Wayzata Planning Commission

Meeting Agenda

Monday, August 20, 2018
7:00 p.m.

Project Name:	Ventana Condos
Applicant	Ventana, LLC
Property Owner	Berry & Co, Inc
Addresses of Request:	253 Lake St E
Prepared by:	Jeff Thomson, Director of Planning and Building
“60 Day” Deadline:	October 20, 2018 (120 day extension)

LOWER & MAIN LEVEL PLAN

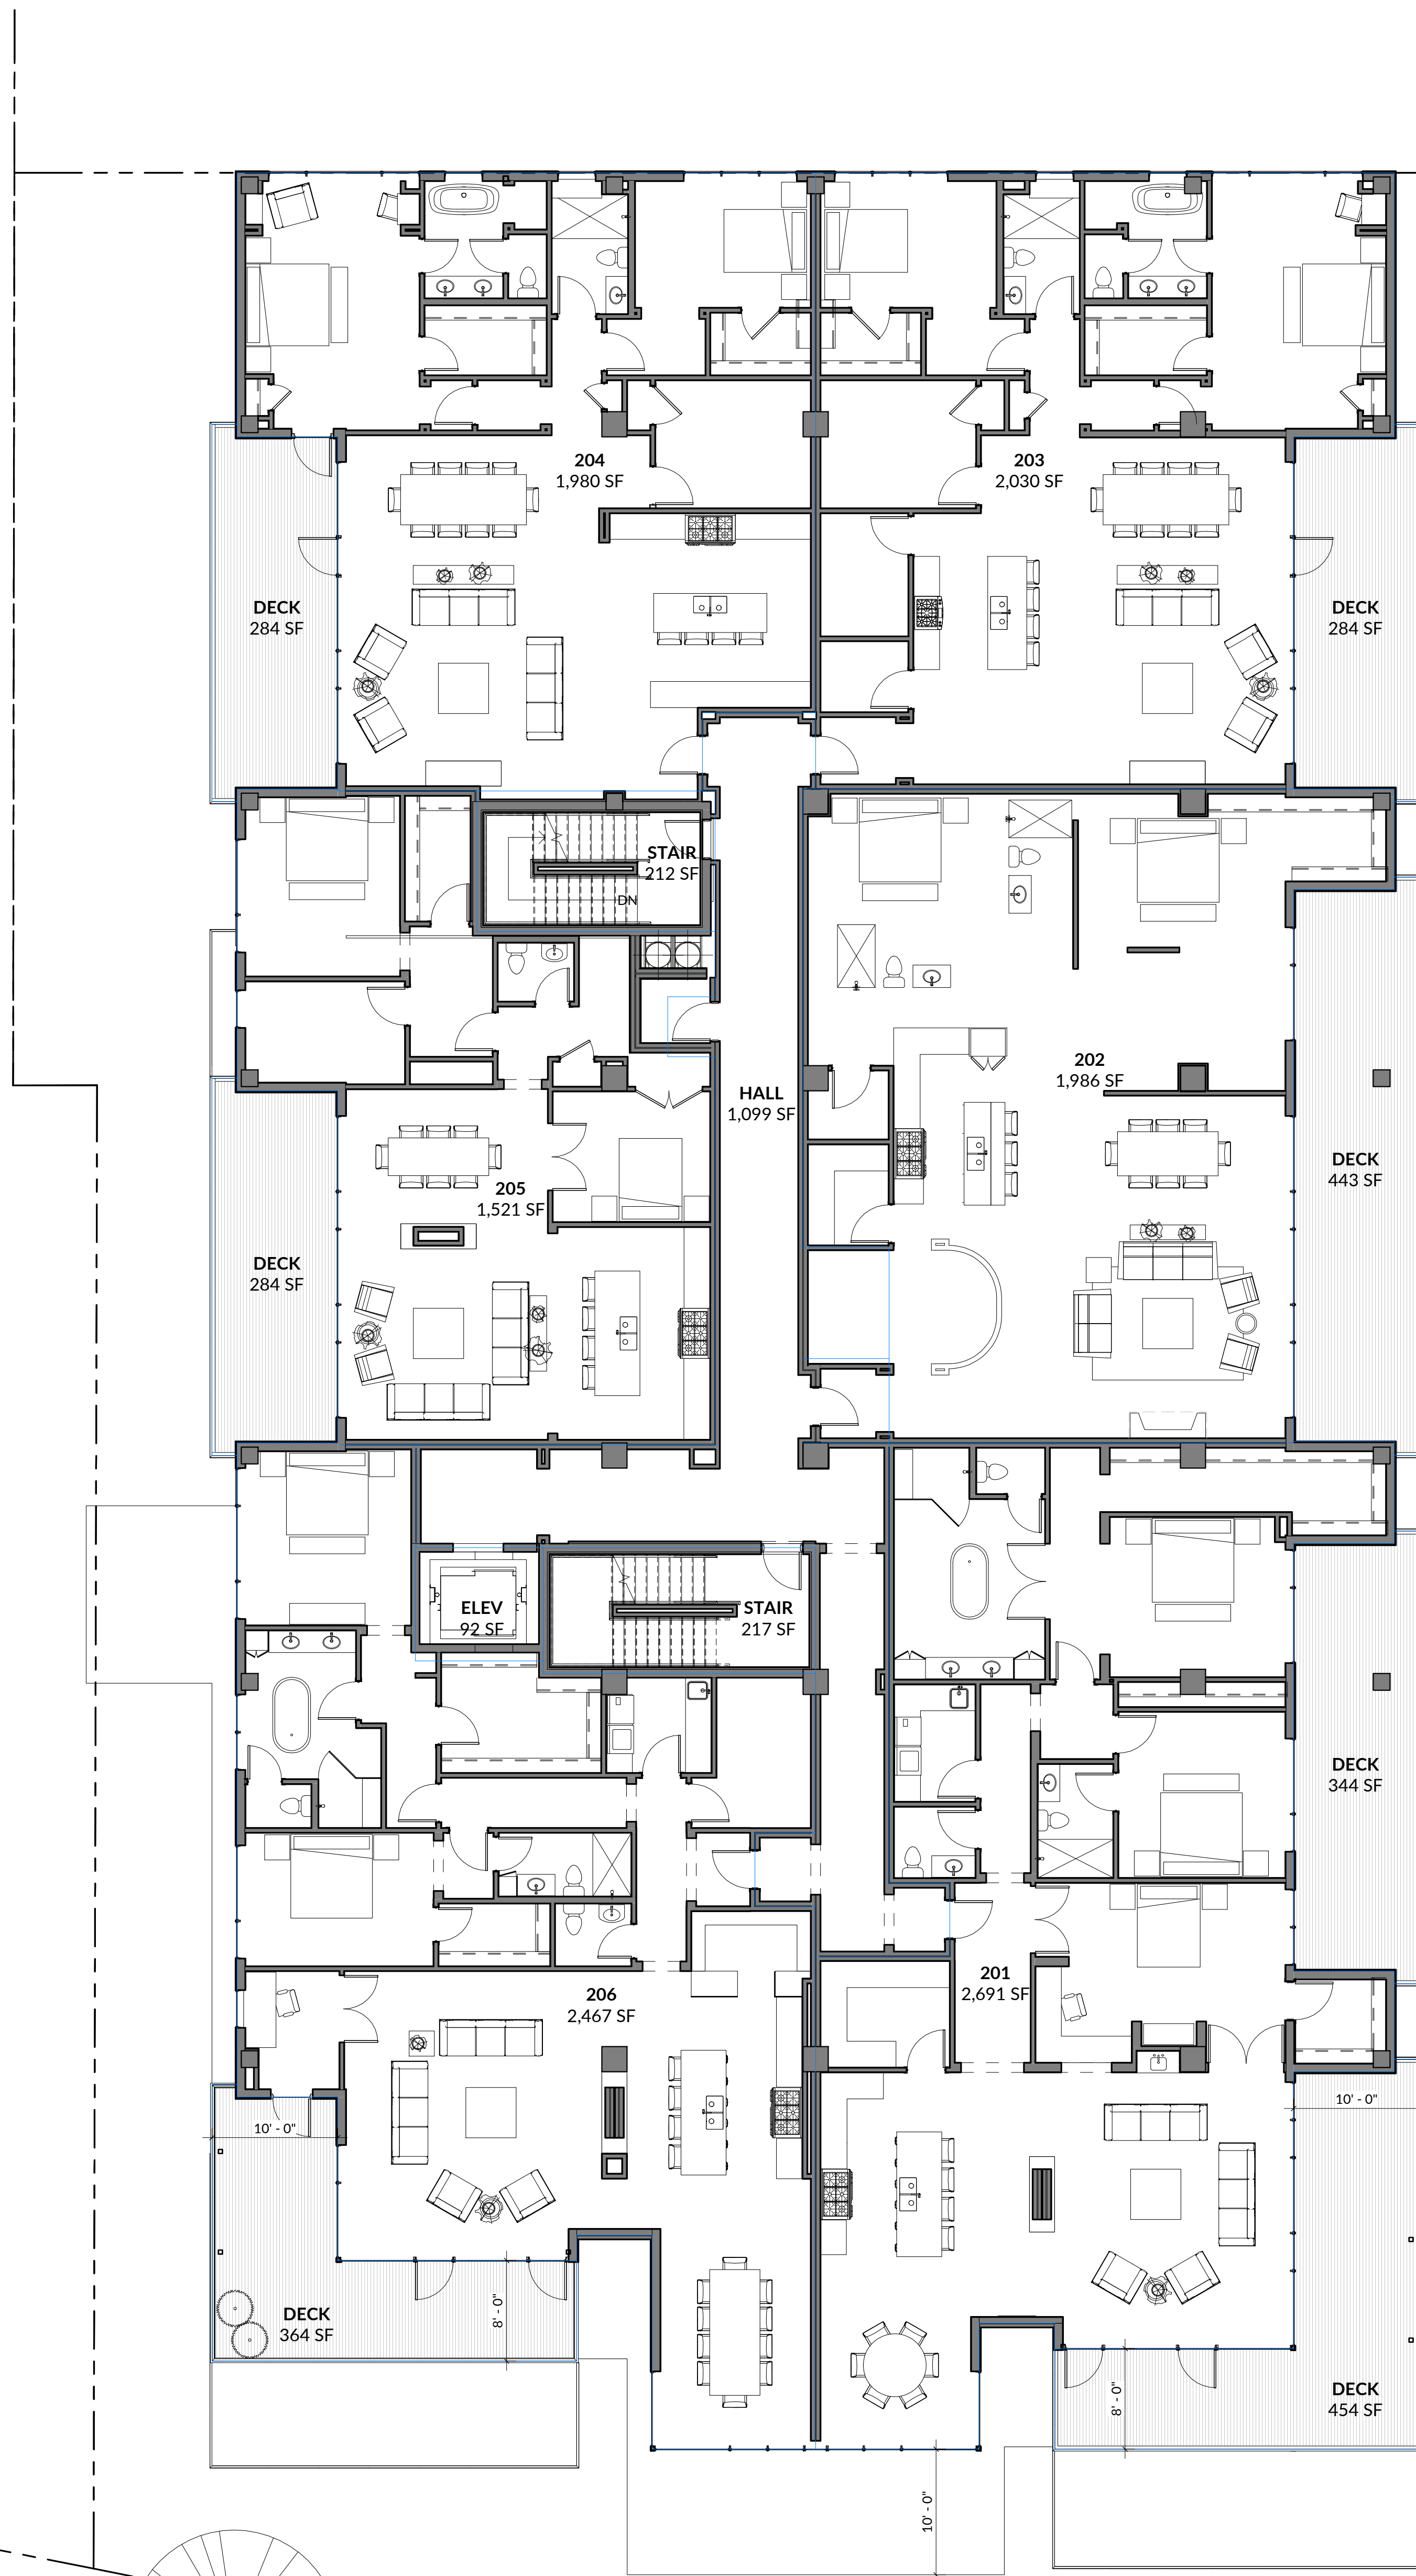
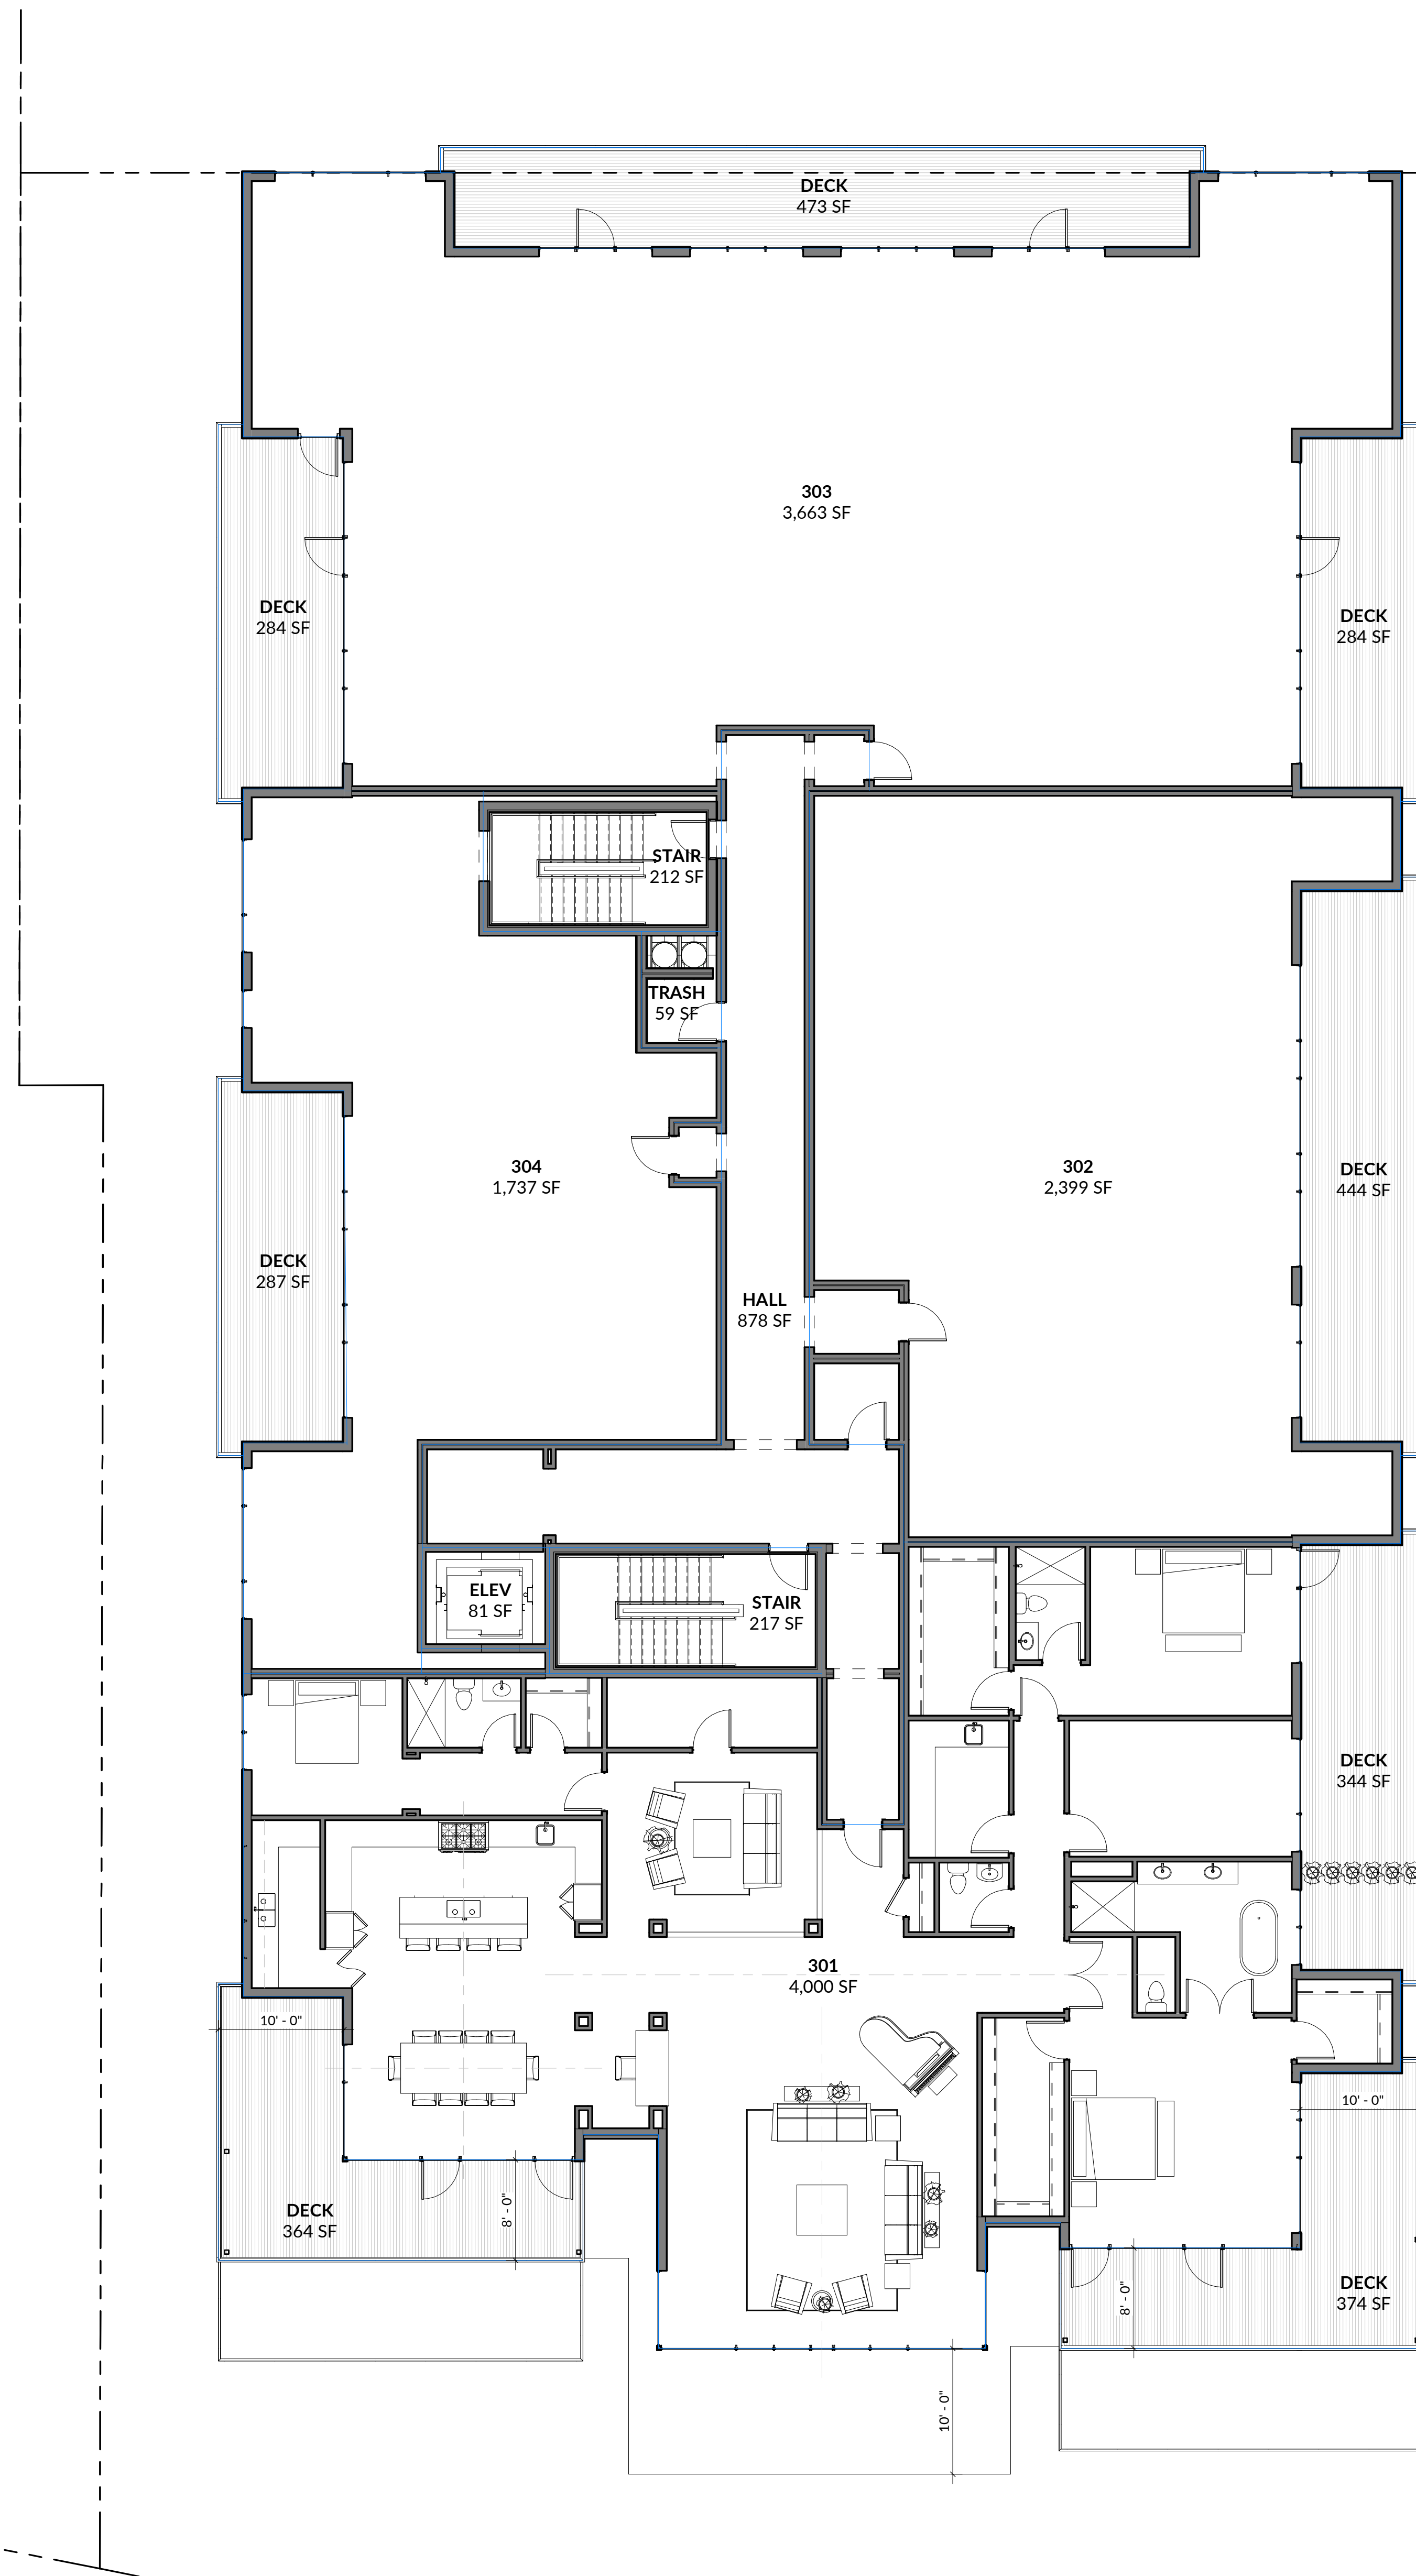
- Front Door Location: The design standards state that the main entrance to the building must face the primary street at sidewalk grade. The proposed plans have the main entrance at sidewalk level, but on the side of the building and not on Lake Street. The primary reason for the entrance location is (1) the residential uses on the first floor; (2) the width of the building; and (3) the functionality of the first level floor plan.

Entries		
<u>801.09.10.1 – All Districts</u> The front facade of all buildings shall be landscaped with window boxes or planters with seasonally appropriate plantings. The main entries shall face the primary street at sidewalk grade.	The front façade has landscaping located in front of the building adjacent to Lake Street. However, the entrance to the building is located at sidewalk level on the side of the building, and not directly on Lake Street.	No. Deviation requested.
